Re: Fairfield Townhomes – Site Plan and Subdivision Plat
Application Number: DA-1556-25
Case Numbers: 2022-4012-00; 2022-3018-00

Technical Corrections Review

FAIRFIELD TOWNHOMES | SITE PLAN

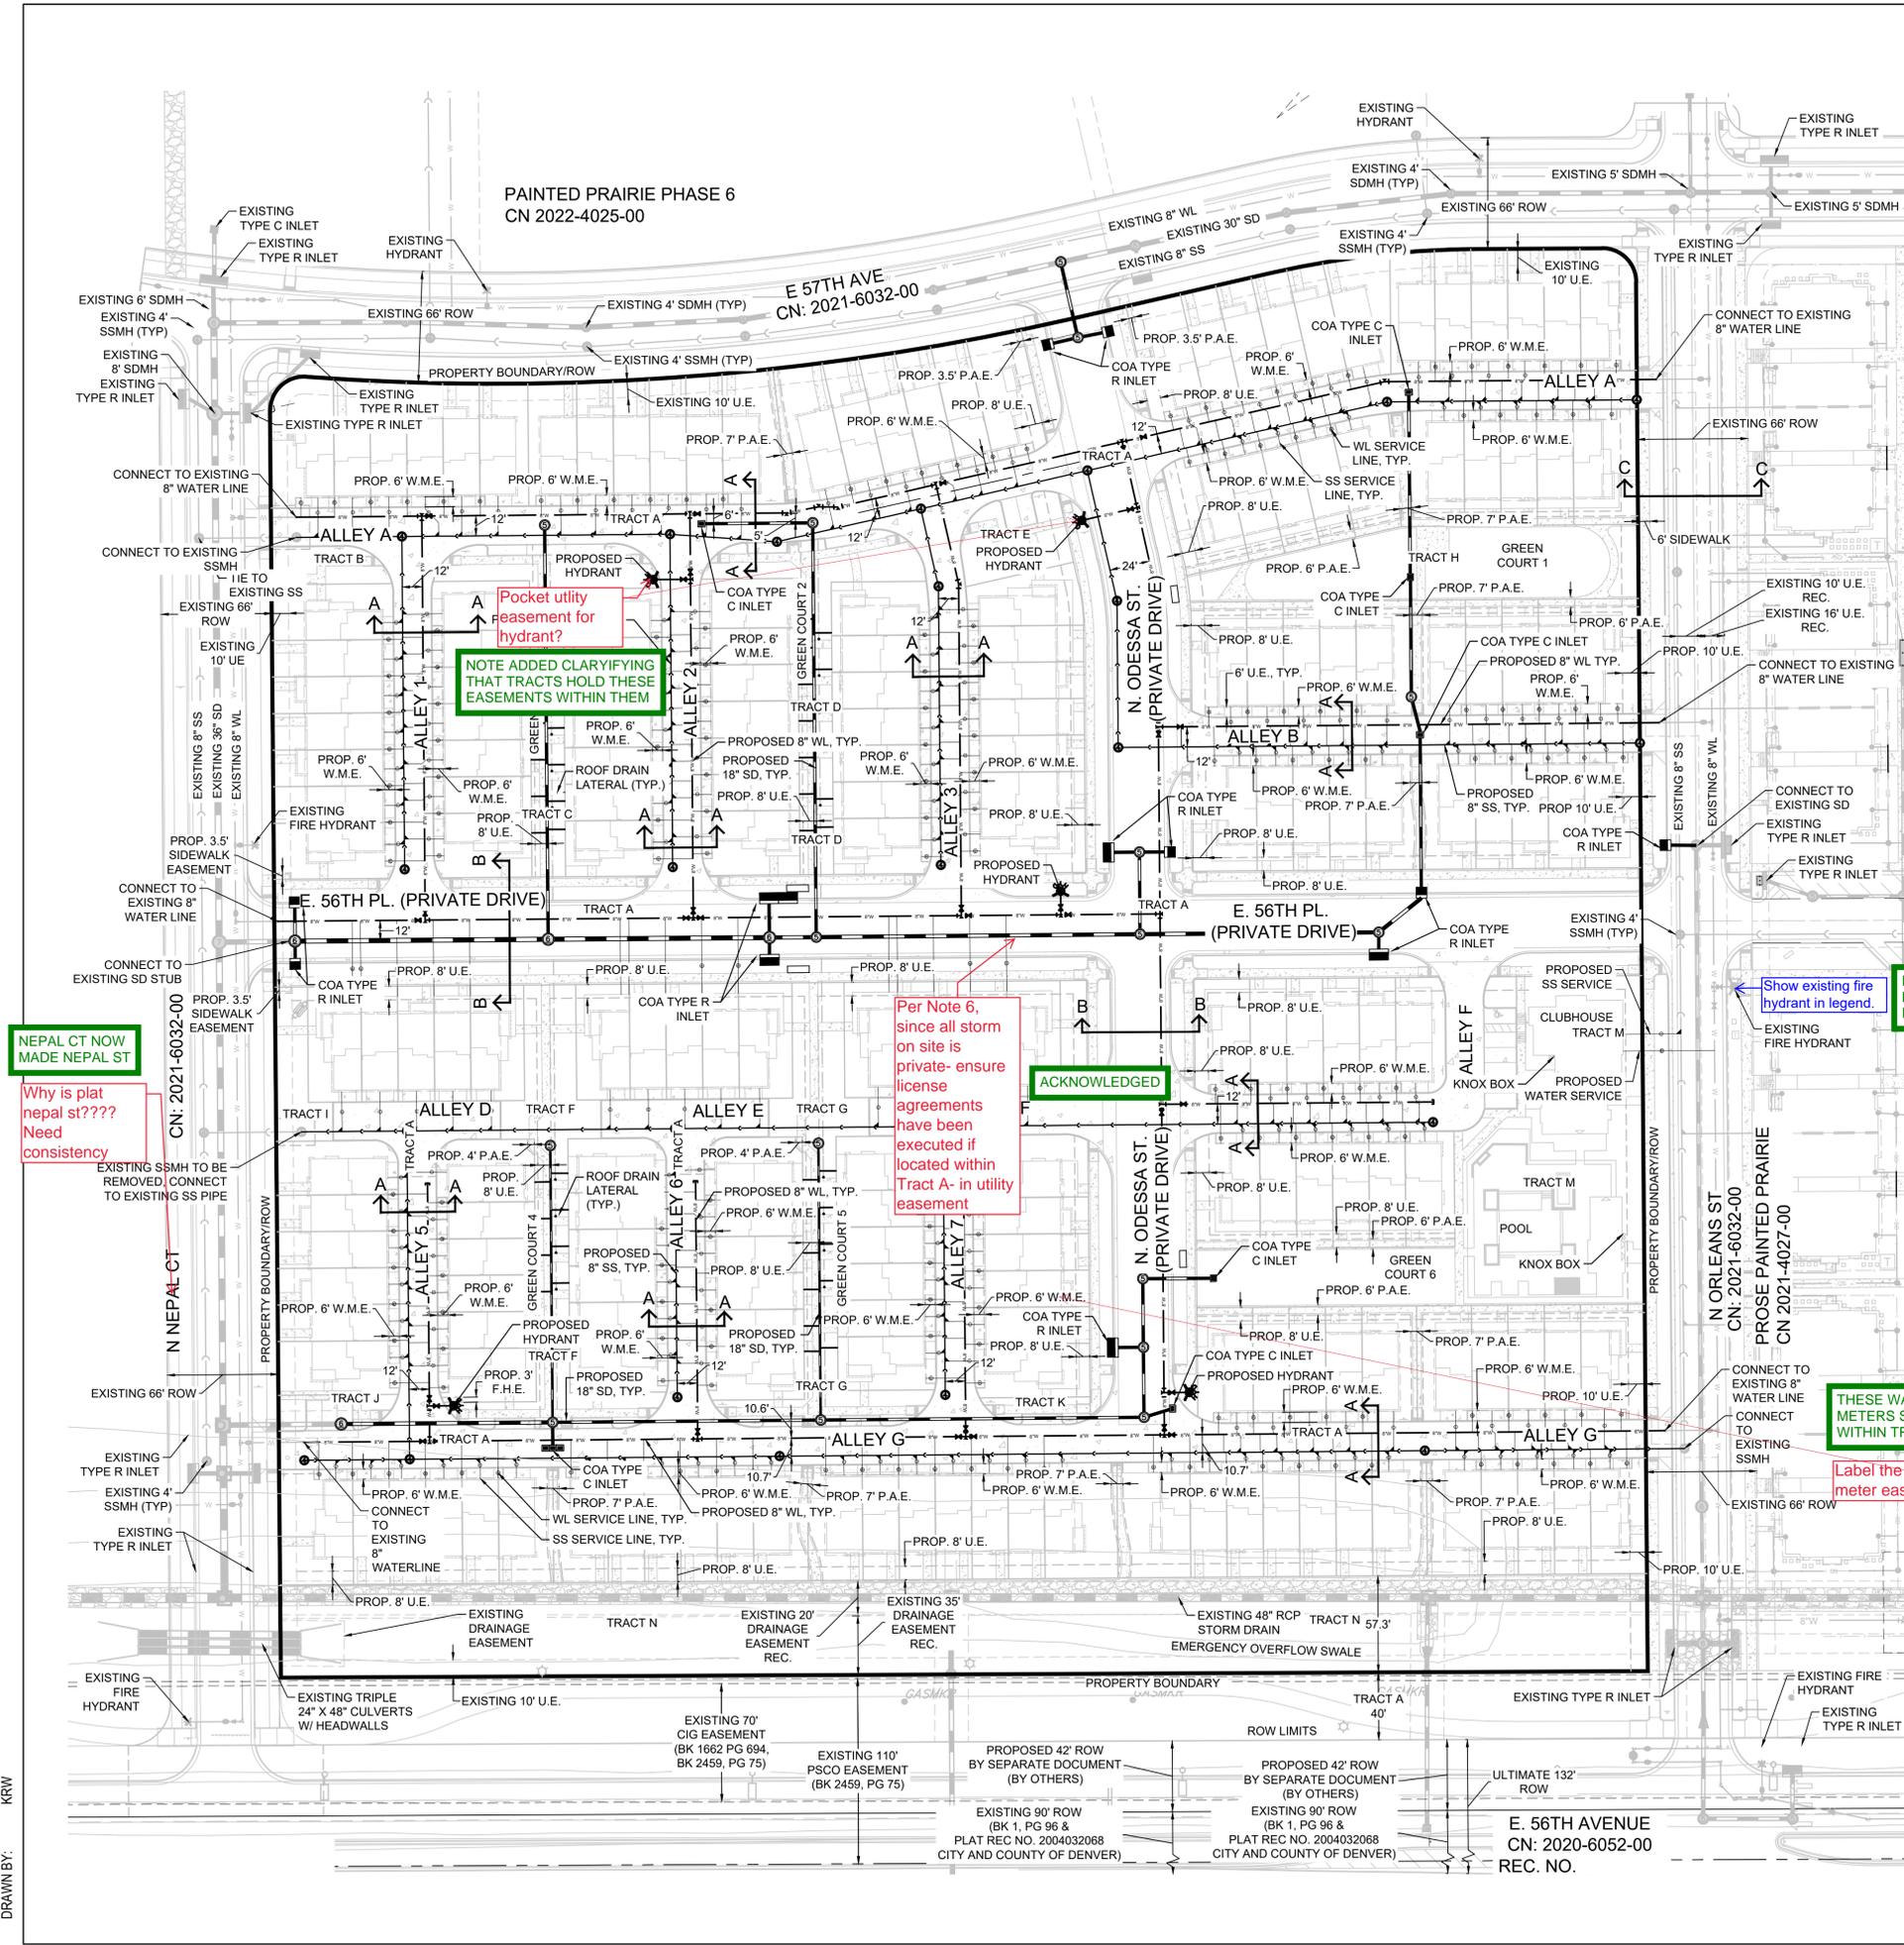
NEPAL CT NOW MADE NEPAL ST
 Why is plat nepal st????
 Need consistency

Pocket utility easement for hydrant?
 NOTE ADDED CLARIFYING THAT TRACTS HOLD THESE EASEMENTS WITHIN THEM

Per Note 6, since all storm on site is private- ensure license agreements have been executed if located within Tract A- in utility easement

Show existing fire hydrant in legend.

ACKNOWLEDGED

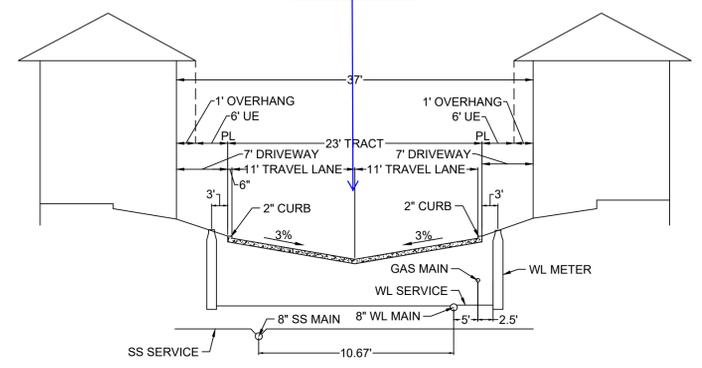
Show and label the 23' fire lane easement.

REFER TO NOTE 2 FOUND THROUGHOUT THE CSP SHEETS. FIRE LANE EASEMENTS WILL BE ENCOMPASSED WITHIN TRACT A.

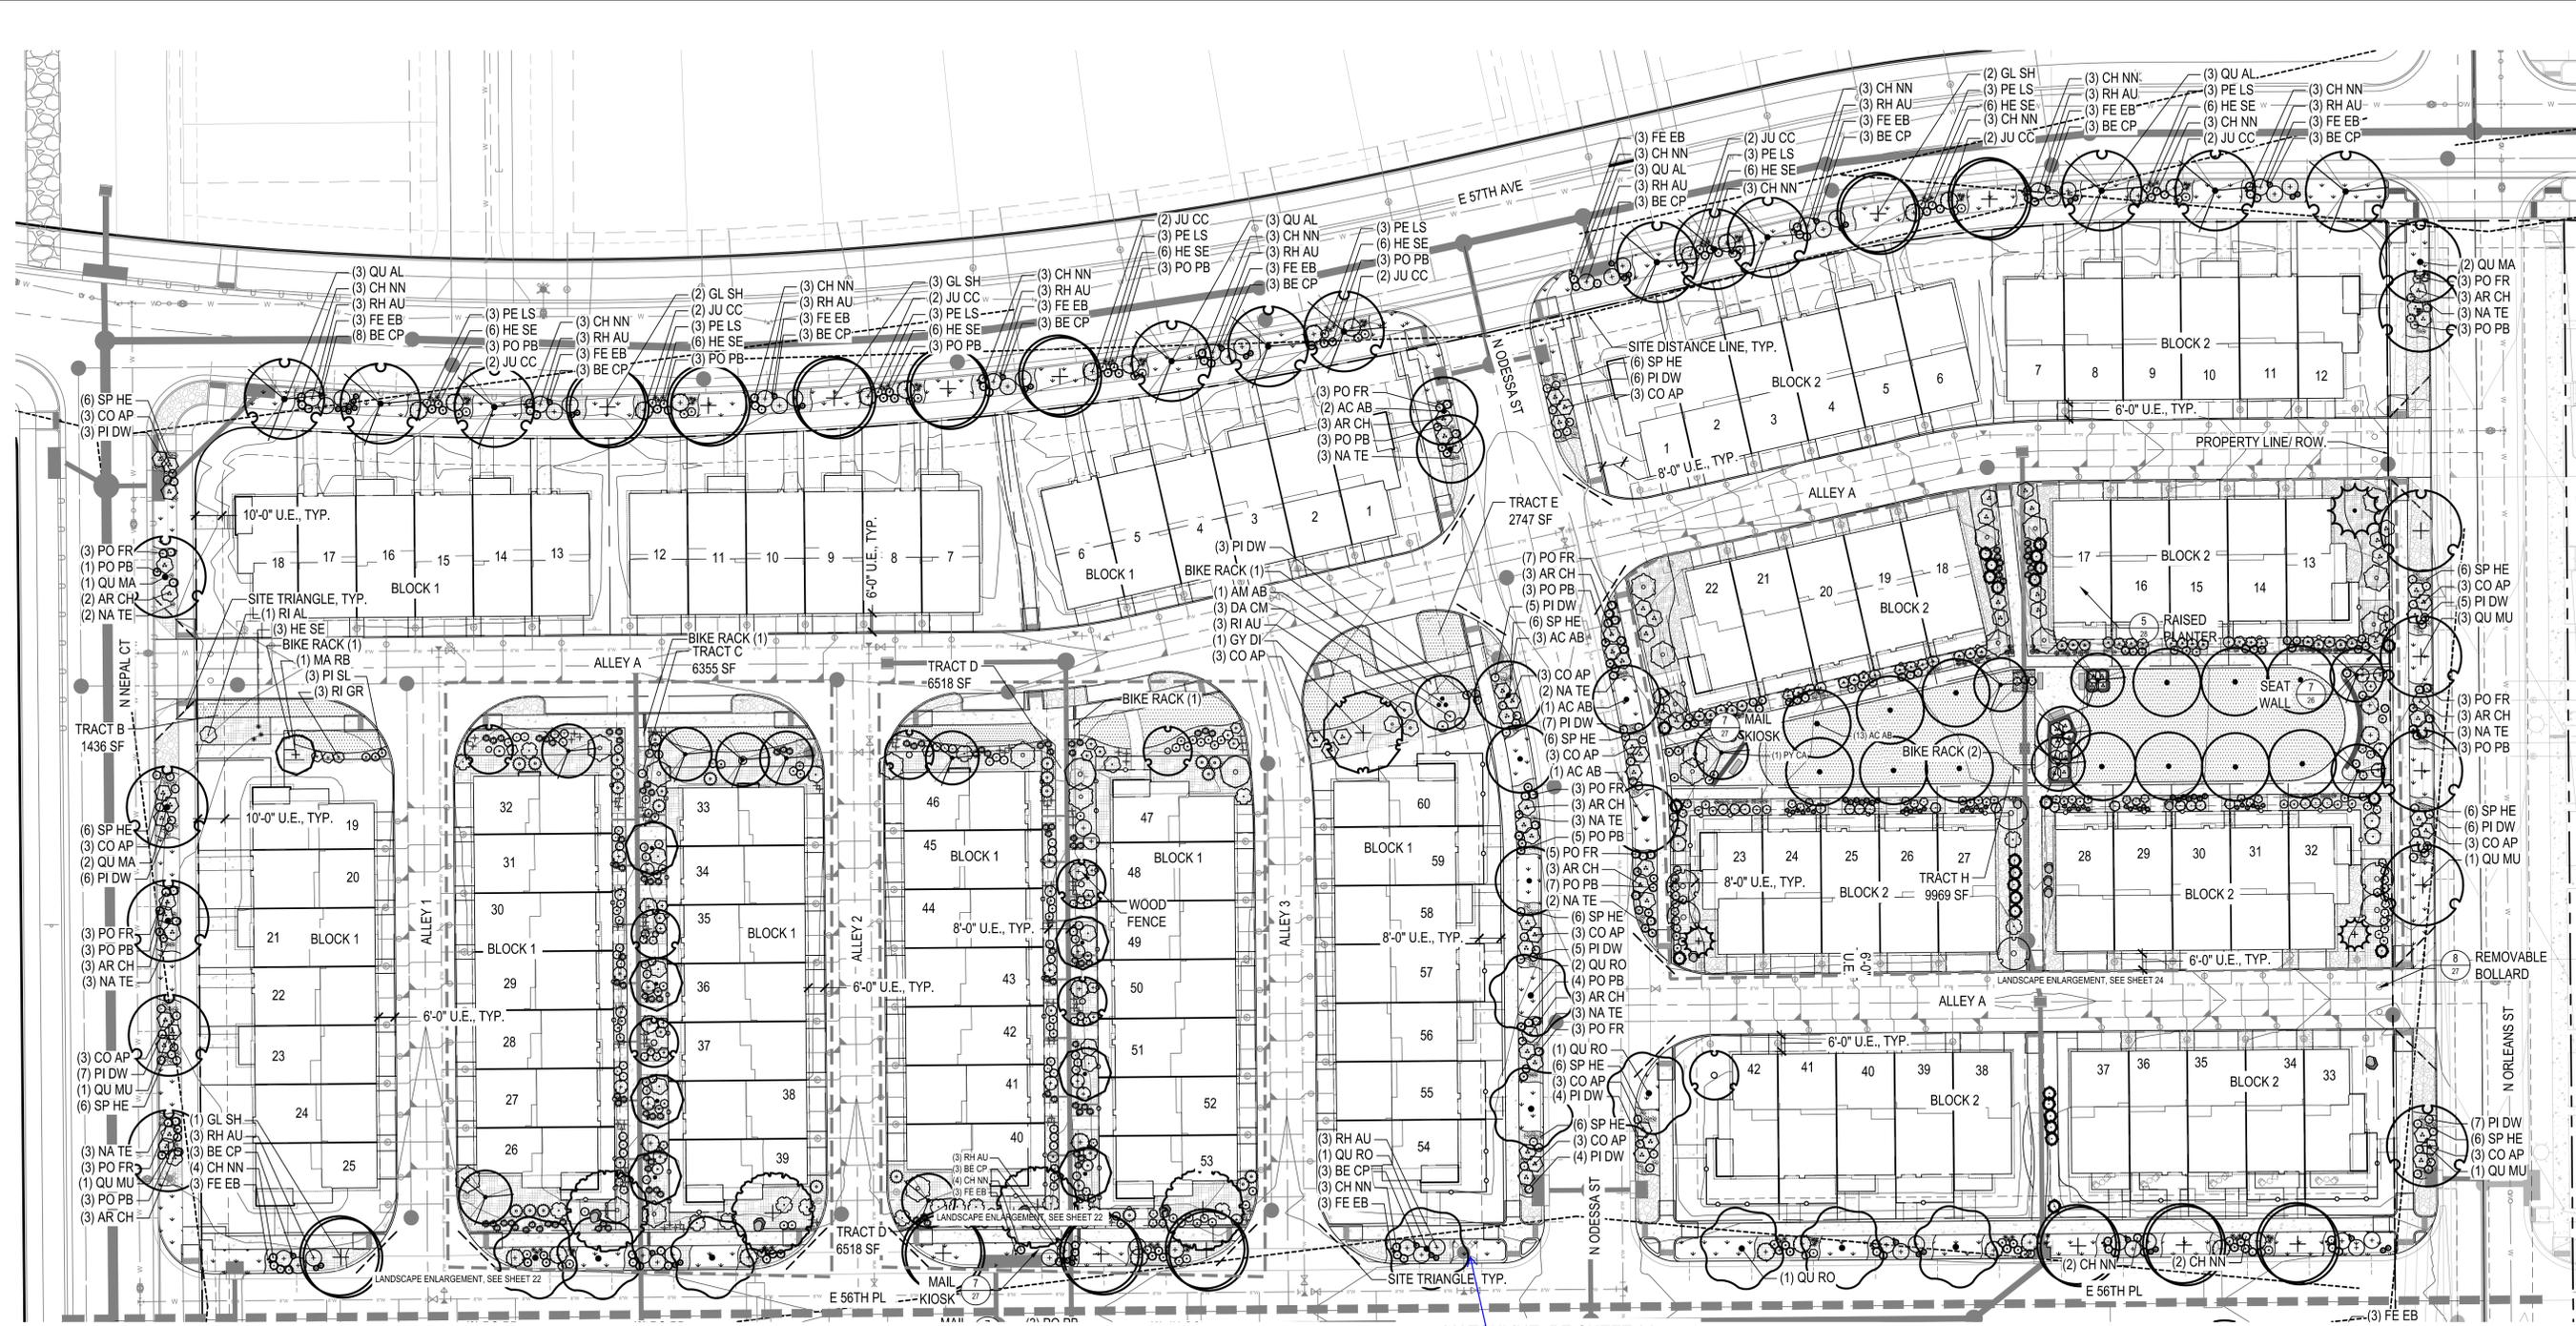
Grasses that are to 5 gallon should be listed as such in this table. A note will not suffice.

RESPONSE: ALL GRASSES HAVE BEEN UPDATED TO #5

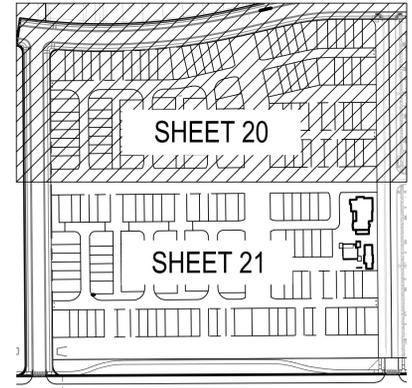
Call-out fire hydrant and show in legend. Typical
RESPONSE: HYDRANT AND HYDRANT LABEL HAVE BEEN ADDED TO SHEETS AND LEGEND

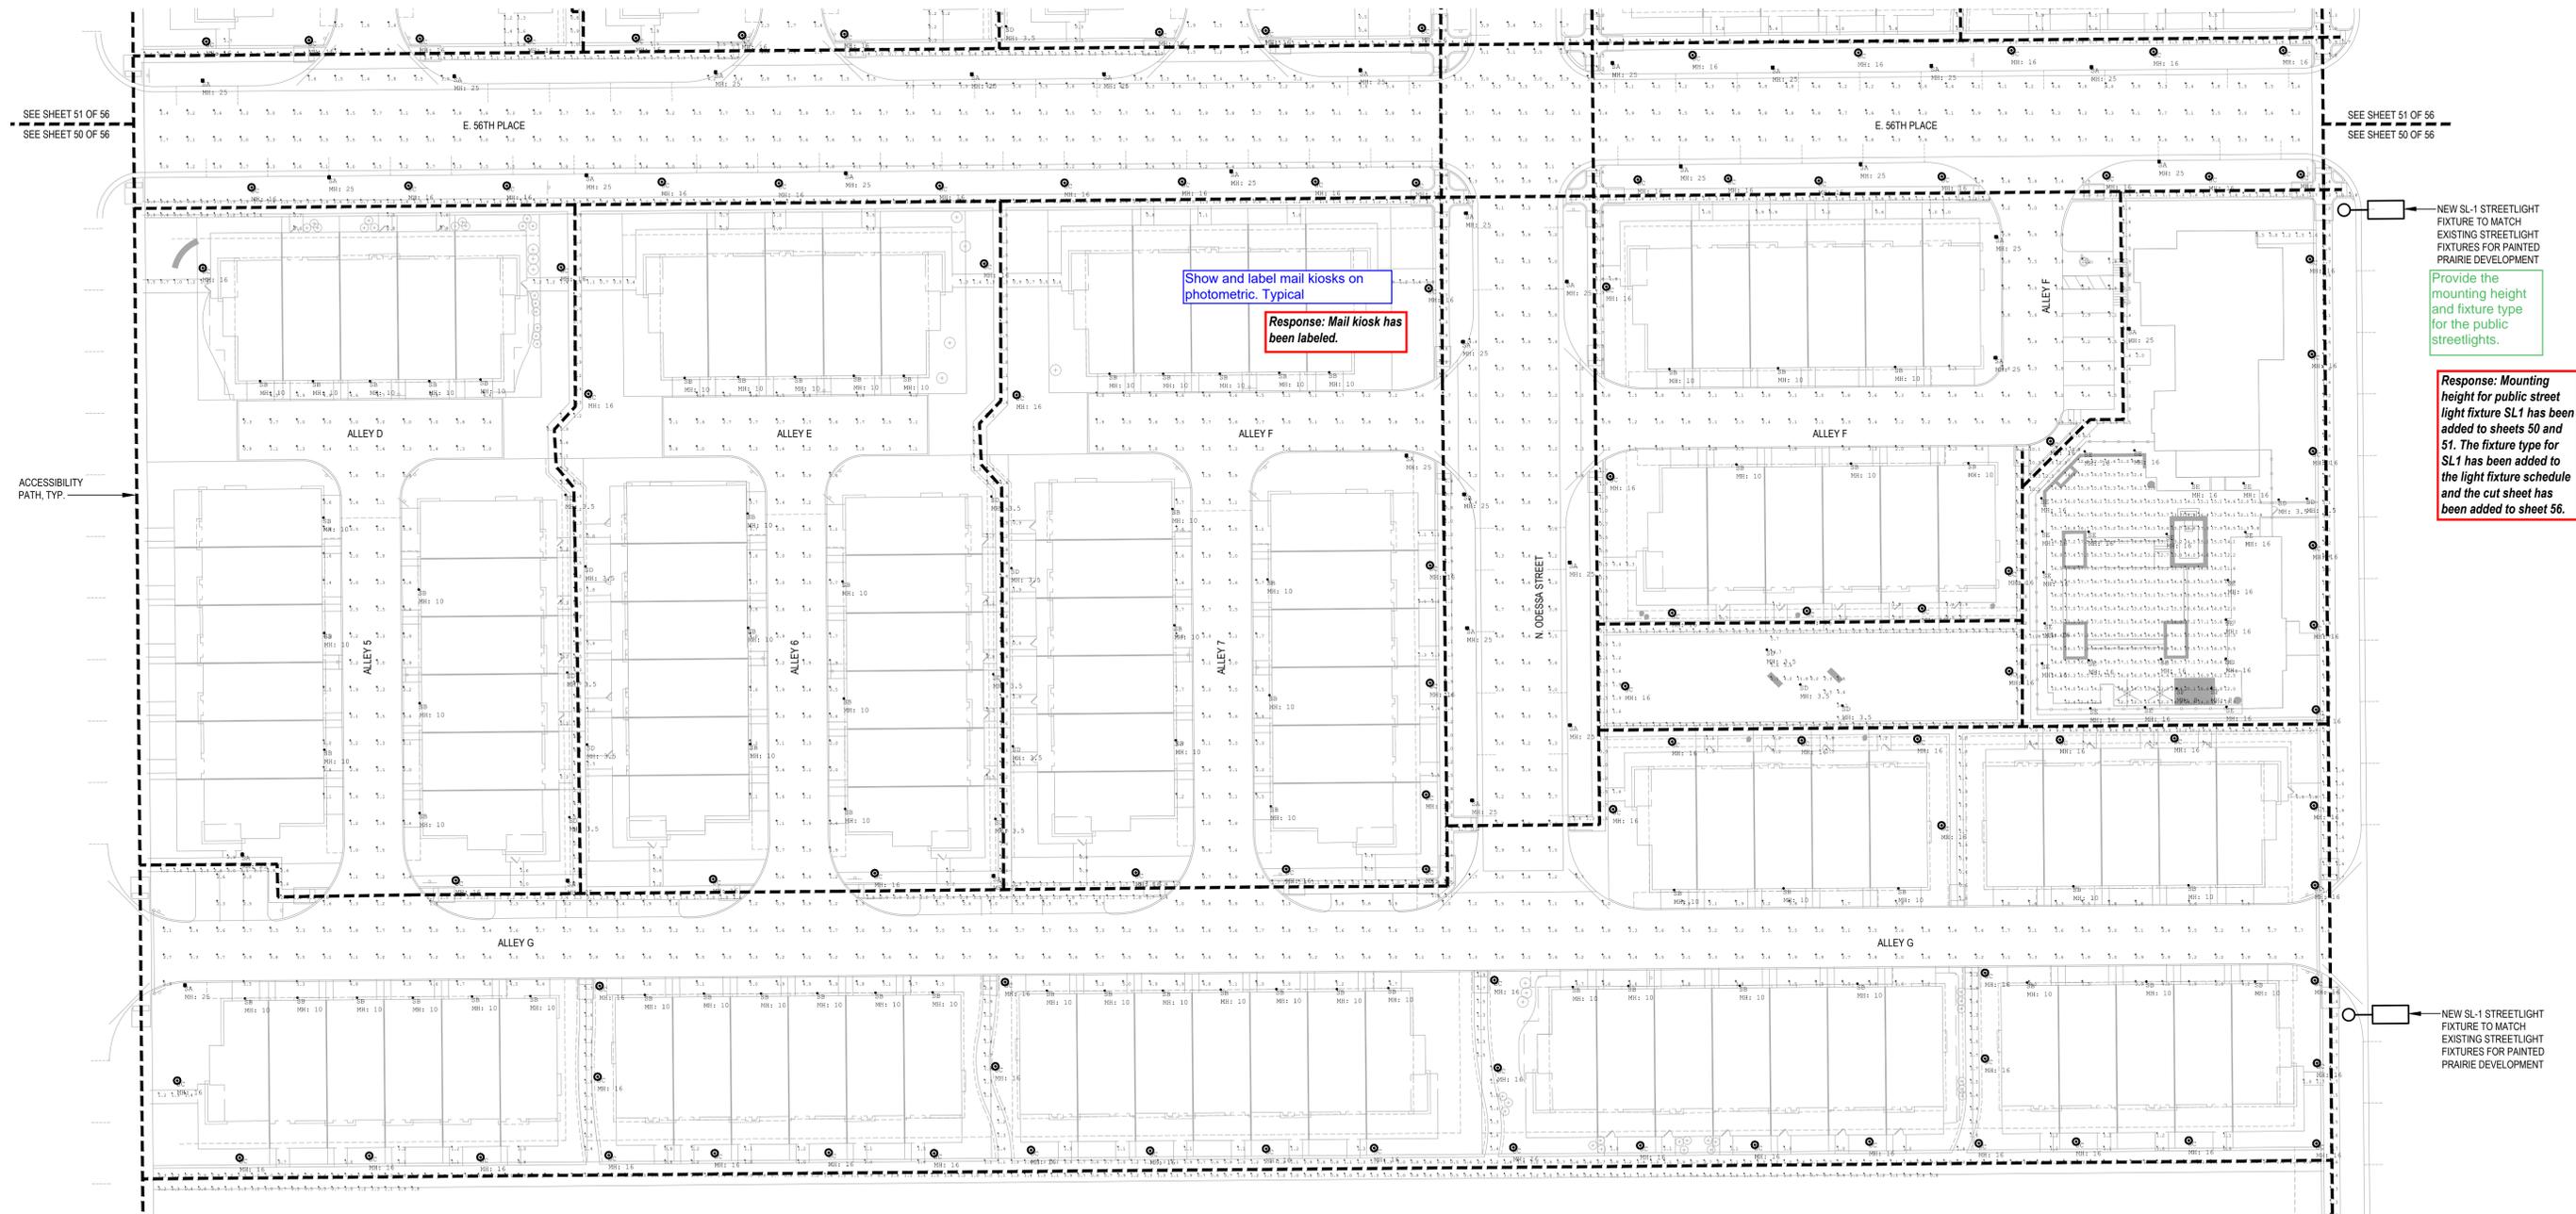
3F. Provide the mounting height and fixture type for the public street lights.

Response: Mounting height for public street light fixture SL1 has been added to sheets 50 and 51. The fixture type for SL1 has been added to the light fixture schedule and the cut sheet has been added to sheet 56.
